City of Richmond
Planning and Development Department

Report to Development Permit Panel

To: Development Permit Panel
From: Jean Lamontagne
Director of Development
Date: January 20, 2006
File: DP 06-333449
Re: **Application by Am-Pri Construction Ltd. for a Development Permit at
9451 Granville Avenue (formerly 9415, 9431 and 9451 Granville Avenue)**

PLAN # 3a

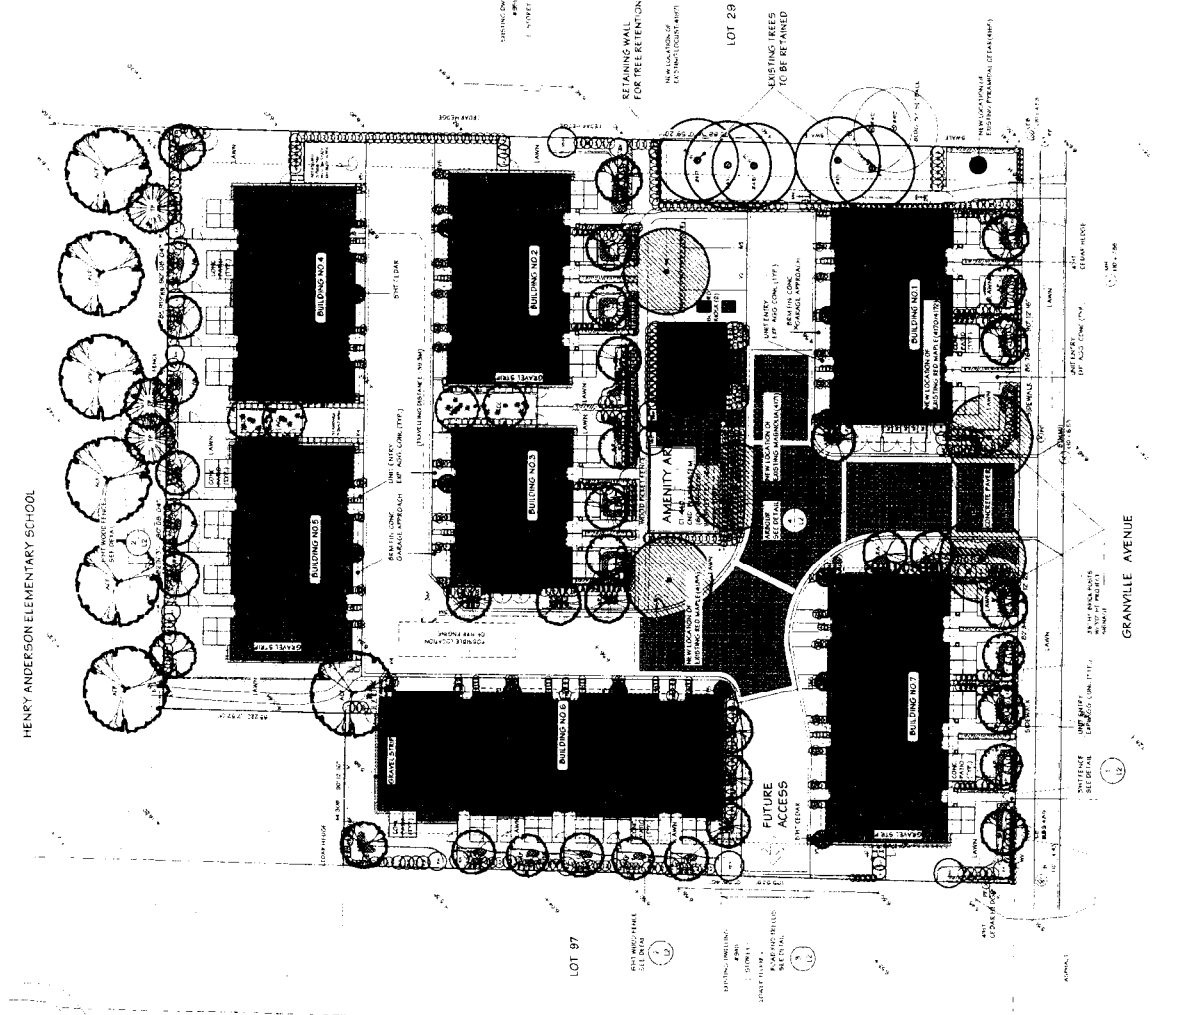
- Design development to landscaping design, including the retention or replacement of existing trees – ***completed landscape plan included in development proposal (Plans #3a and #3b). The applicant proposes retention and protection of the 6 existing trees (4 on the subject property and 2 at 9511 Granville Ave) along the east property. As well, the developer is proposing to transplant 6 existing trees onsite. A tree survey plan and Arborist report are included as Attachment 3***;

- The Granville Avenue streetscape is animated with pedestrian-oriented front entries (**Plans #3a and #4**);
- Vehicle access is provided from Granville Avenue with moving truck loading onsite in the drive aisle. Cross access was secured through the rezoning for the benefit of future development site to the west at 9411 Granville, and to the east at 9511 Granville through the previous rezoning for 9533 Granville Avenue (DP 03- 252267);

PLAN #3b
DP 06333449
JAN 23 2007

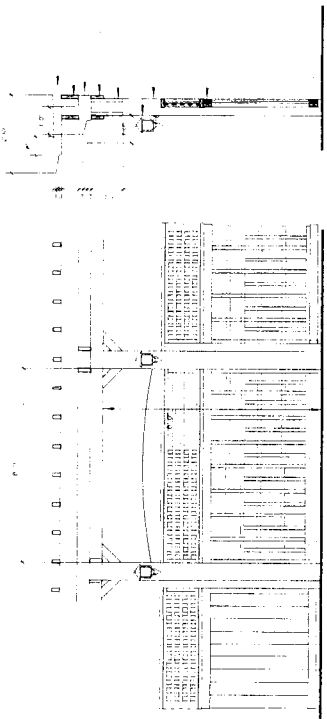
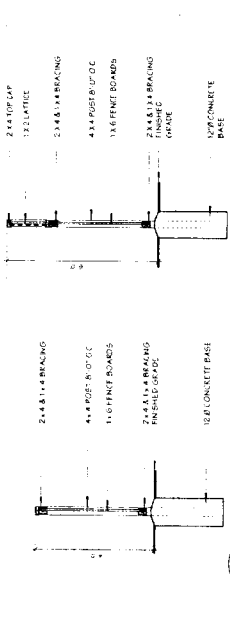
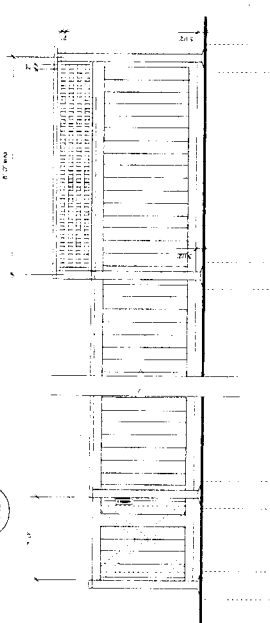
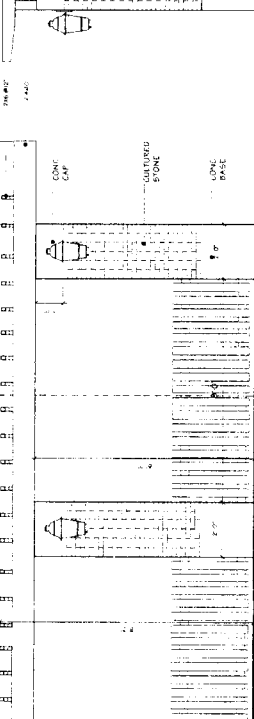
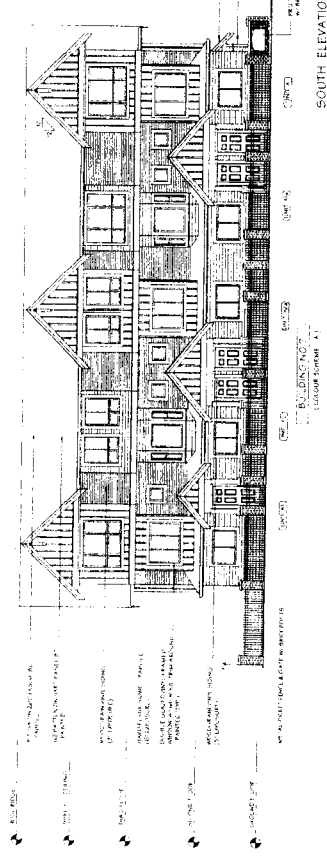
- Headlight glare into adjacent single-family lots is mitigated by existing trees, hedge planting, 1.8 m height privacy fencing, and a road end trellis (**Plan #3b**);

DP 06333449
 PLAN #4

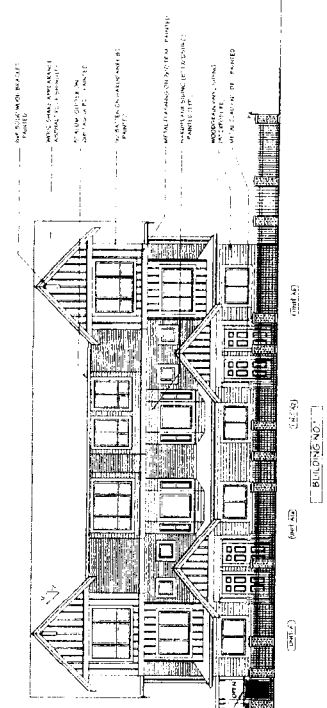
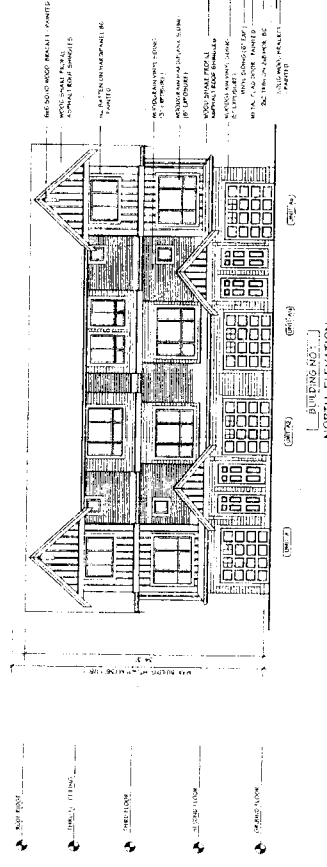
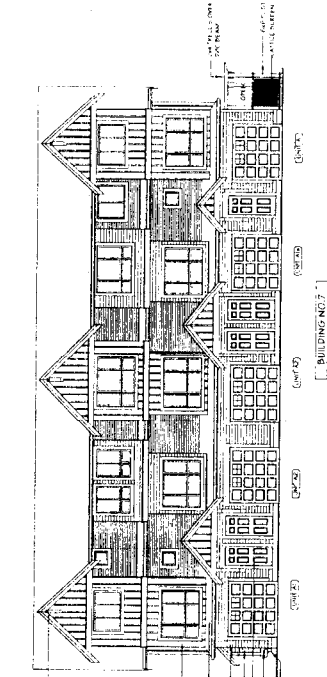
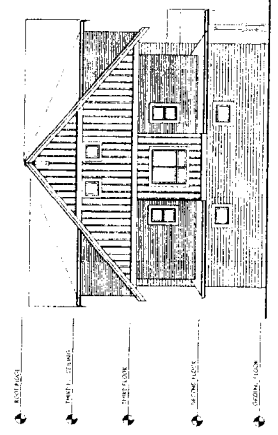
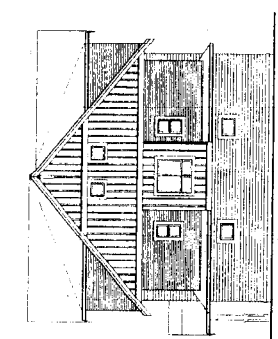
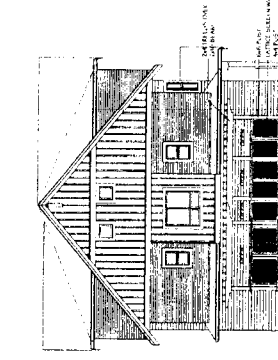
- design development to the elevations to simplify and reduce the sharpness of the roof lines;
Rooflines have been modified and projecting bays reconfigured for more coherent elevations. See attached elevations.
- garbage area needs to be addressed for accessibility;
Garbage and recycling enclosures relocated to more central location that is accessed from the drive aisle.
- consider access to the elementary school.
Access has been provided to the elementary school through a path and gate at the northwest corner of the site.

JAN 23 2007
REFERENCE PLAN
DP 06333449
PLAN #9
SHEET 9
9
9
9

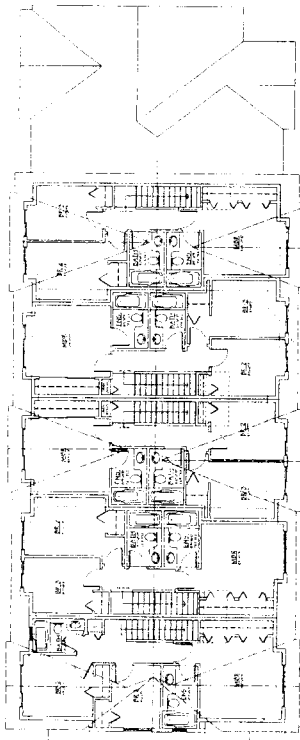
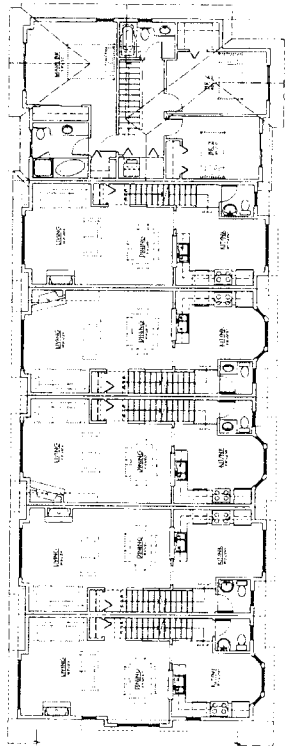
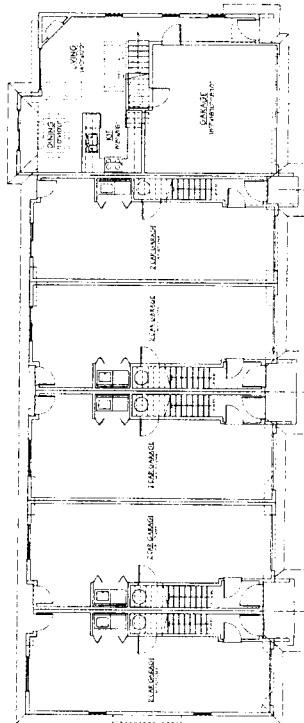
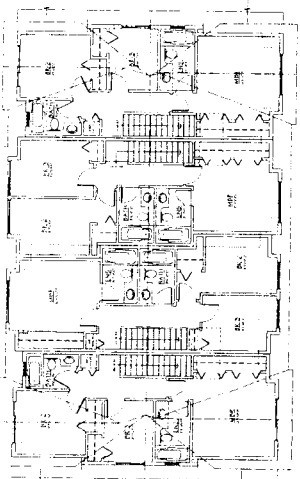
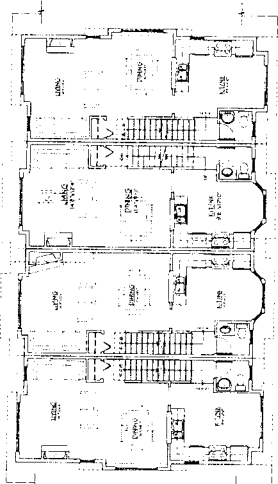
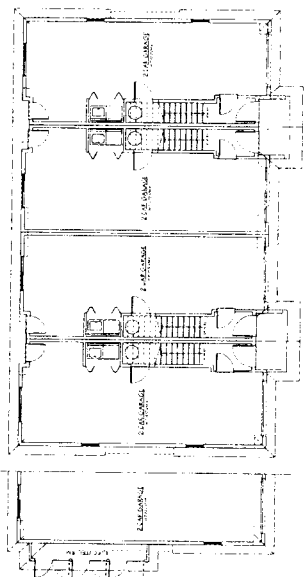
- One convertible accessible unit has been provided in this 30-unit development. An alternate floor plan demonstrating conversion potential to accommodate a person in a wheelchair is provided for the one (1) two-storey "C" unit with the installation of an elevator within the garage to the second floor (**Plan #9**);
